Re: *Application No. SP 1133-20*
Linden Development, LLC.
Amended Preliminary & Final Major Site Plan
Proposed Starbucks Restaurant with Drive-Thru
Portion of Block 469 Lot 38.05
1016 West Edgar Road, Linden, NJ

Application No. SD 756-20
Linden Development, LLC.
Amended Preliminary & Final Major Subdivision Plan
Block 469 Lot 38.05
1016 West Edgar Road, Linden, NJ

DETAIL OF CROSSWALK

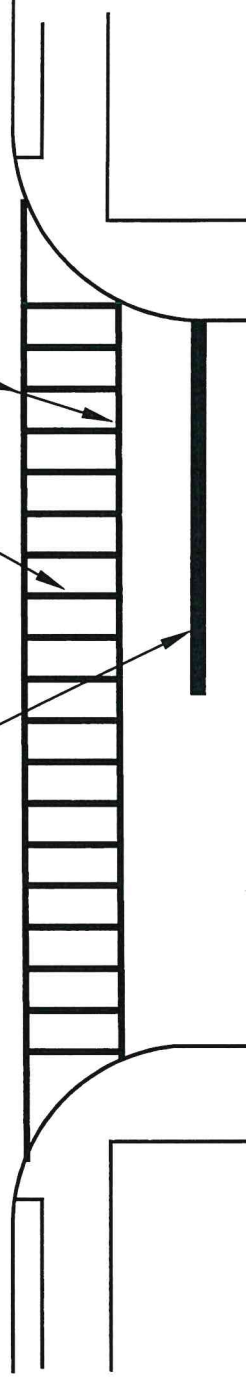
- The Painted Crosswalk Striping Detail shall be replaced with the City's Standard Traffic Striping: Two 8-inch lines, 6 feet apart along the length and hatched with 12-inch-thick crossbars 3 feet apart from the center;

NOTE: CROSSWALK HATCHING IS REQUIRED AR ALL CROSSWALKS. ALL HATCHING SHALL BE 12" WIDE SOLID WHITE LINES, UNLESS DIRECTED OTHERWISE BY THE ENGINEER AND SPACED 3 FEET ON CENTER. ALL HATCHING SHALL BE PLACED AT PARALLEL TO CENTERLINE STRIPING.

8" WHITE LINES WIDTH OF
CROSSWALK, SAME AS
EXISTING, 6' MIN, 8'
PREFERRED
